New Albany Architectural Review Board Agenda (Amended)
Monday, January 10, 2022 7:00pm

**New Albany Architectural Review Board
December 13, 2021 DRAFT Minutes**

Architectural Review Board Staff Report December 13, 2021

SITE PLAN

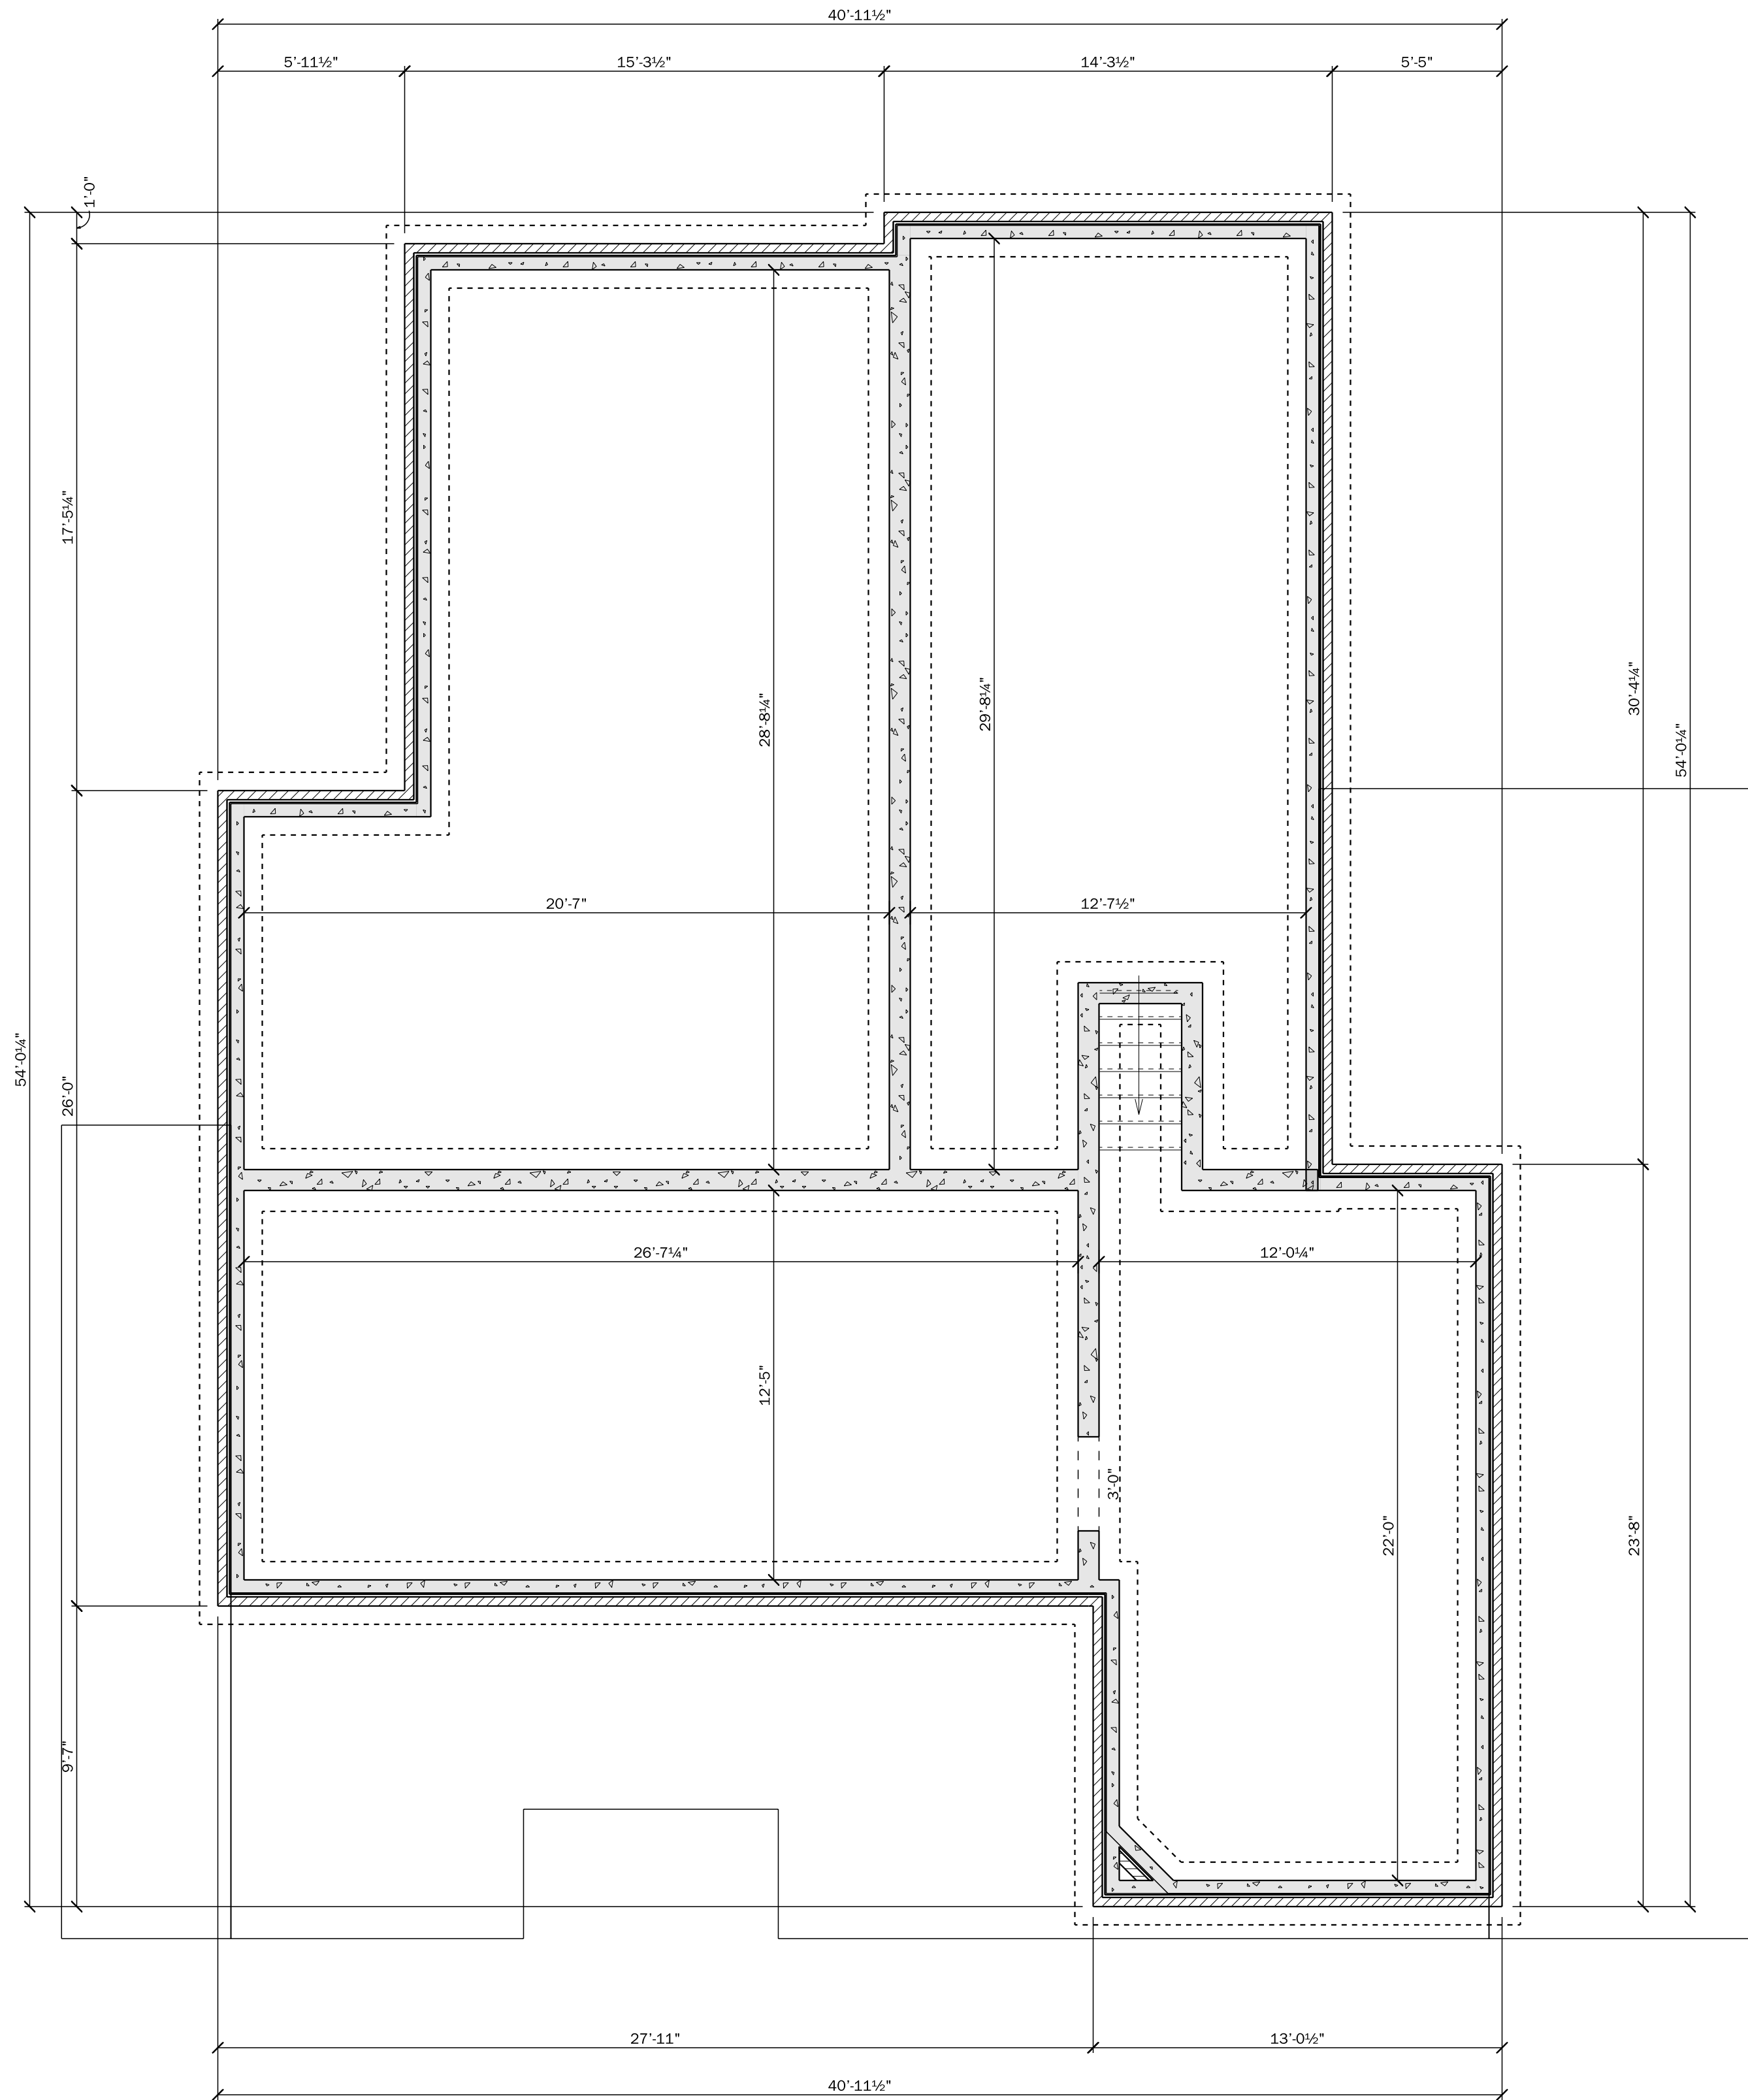
- A site plan was submitted as part of the application however it appears that the location of the parking lot is inconsistent with the Second Street improvement plans that were completed by the city. Staff recommends a condition of approval that the site plan be updated as part of the building permit submittal.

- A new English garden and herb garden are identified on the site plan that were not previously shown however, the details for these areas was not provided as part of the application. Staff recommends a condition of approval that these details be provided with the landscape plan as part of the building permit and be subject to staff approval.

15. The English and herb garden details must be provided as part of the landscape plan and are subject to staff approval.
16. The two lots must be combined.

ARCHITECTURAL SITE PLAN

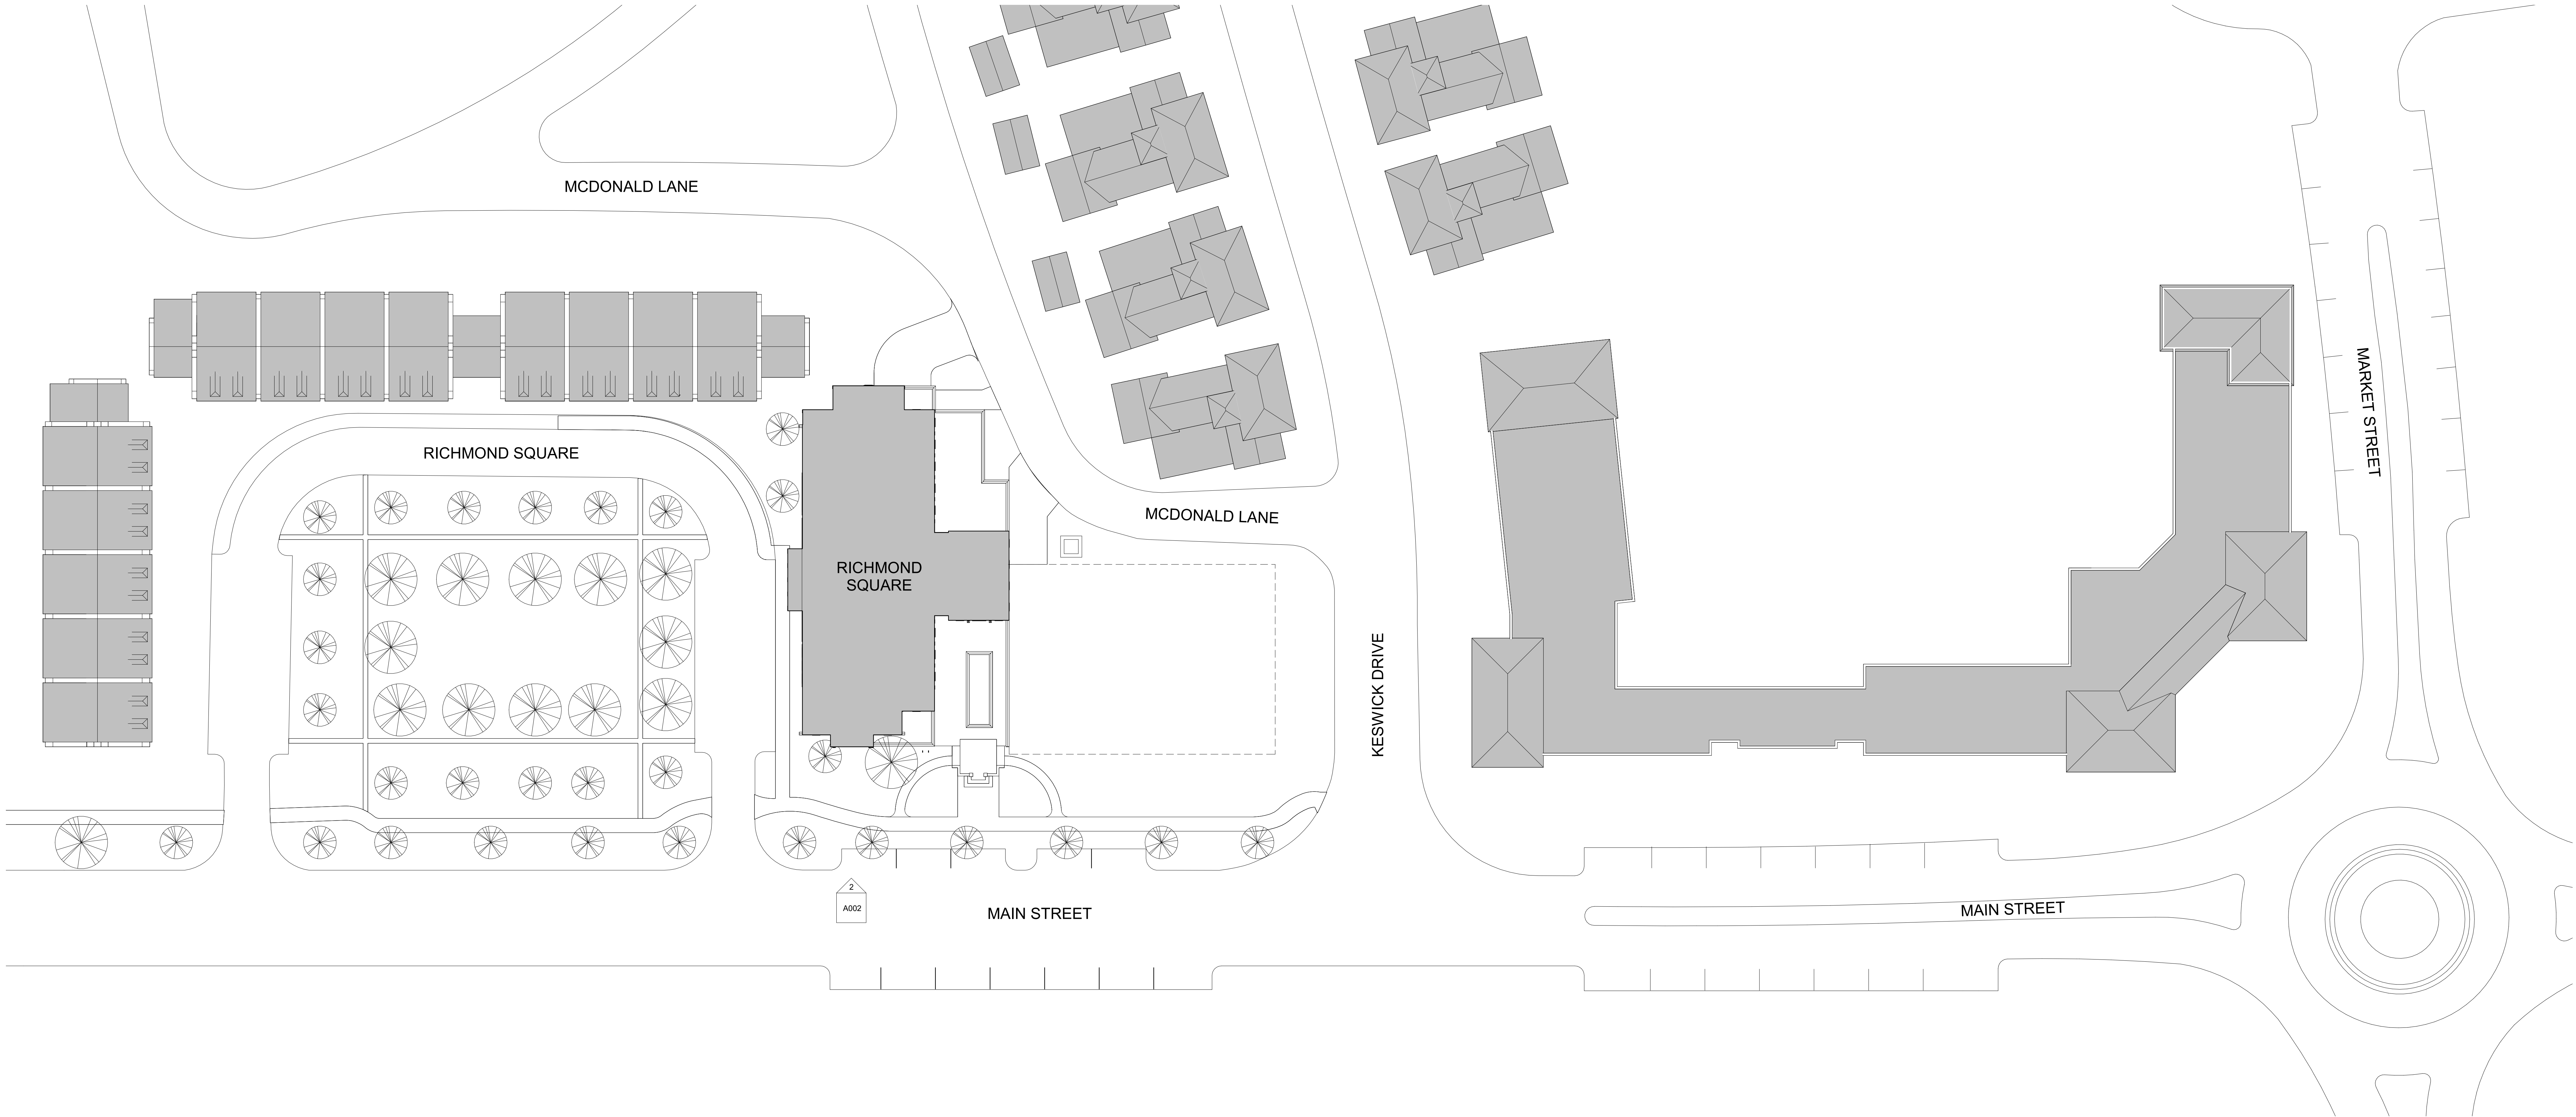
- The conceptual landscape plan shows several improvements near the courtyard area that are located within the right-of-way including an urn and private landscaping. Staff recommends a condition of approval that the urn be relocated outside of the right-of-way and that the applicant enter into an agreement with the city that the proposed courtyard landscaping be maintained by the property owner, and not the city, in perpetuity.

- Urban Center Code Section 5.1 identifies Richmond Square as a Village Avenue. Per UCC section 5.15, a 6-foot sidewalk is required to be provided along this road frontage and connect into the existing sidewalk along the Main Street frontage. The engineering plans do not show this sidewalk being installed however it is being show on the architectural site plan. Staff recommends a condition of approval that the 6-foot sidewalk be added along Richmond Square and connected into the existing sidewalk sections along both Richmond Square and Main Street.

5. A landscape plan must be submitted and meet all city landscape code requirements, subject to staff approval.
6. The proposed urn must be relocated outside of the right-of-way and the applicant must enter into an agreement with the city that the proposed courtyard landscaping be maintained by the property owner, and not the city, in perpetuity.

7. A lighting plan must be submitted and is subject to staff approval.
8. A 6-foot sidewalk be added along Richmond Square and connected into the existing sidewalk sections along both Richmond Square and Main Street, subject to staff approval.
